| | | | | | | | |
|---------------------------------------|---|-----------------------------|--|--------|--|-------------|----------|
| Type Coffee Vending Machine | Model 9XXX | N° T.I. 04 - 2022 | | | | | |
| Serial Number 20421345 | Subject Z4000 upper piston filter plate improvement | ISSUED FOR (X) | <table border="1"> <tr> <td>Action</td> <td></td> </tr> <tr> <td>Information</td> <td>X</td> </tr> </table> | Action | | Information | X |
| Action | | | | | | | |
| Information | X | | | | | | |

Picture 1

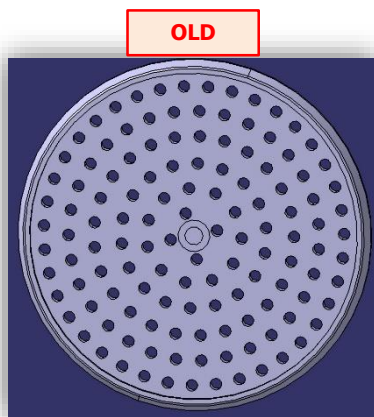
Ten extra studs (orange dots in the picture 3) on the Z4000 brewer upper piston base plate (filter support, part #5 in picture 1) have been implemented.

Picture 2

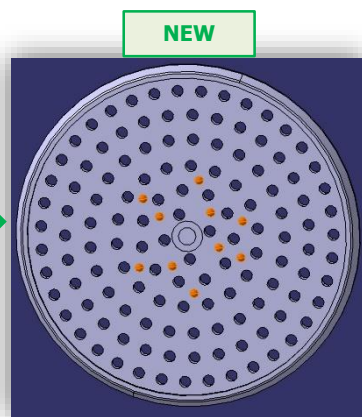
To avoid flow meter error

The spare part code does not change, the new filter support is already available as spare part
